ENGINEER'S STATEMENT

The attached drainage plan and report were prepared under my direction and supervision and are correct to the best of my knowledge and belief. Said drainage report has been prepared according to the criteria established by El Paso County for drainage reports and said report is in conformity with the master plan of the drainage basin. I accept responsibility for any liability caused by any negligent acts, errors, or omissions on my part in preparing this report.

INLET ON A CONTINUOUS GRADE

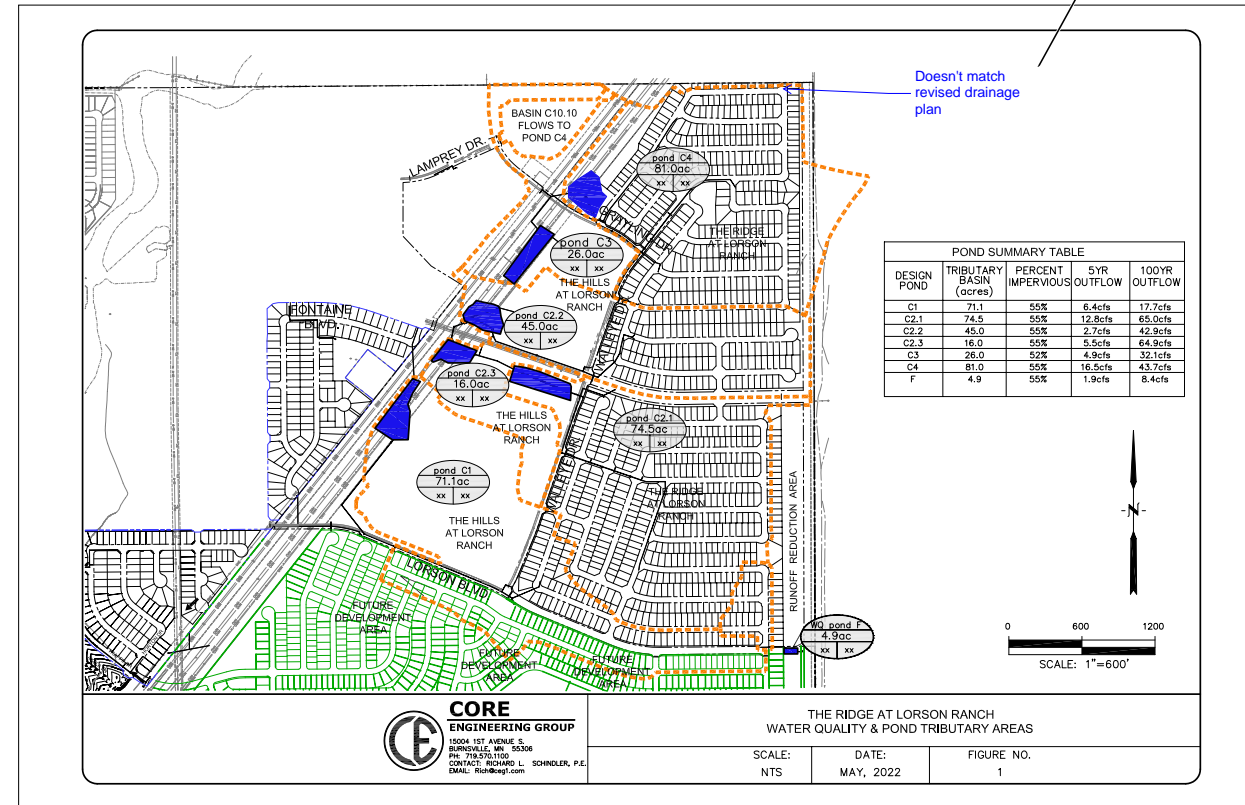
See comment in narrative section
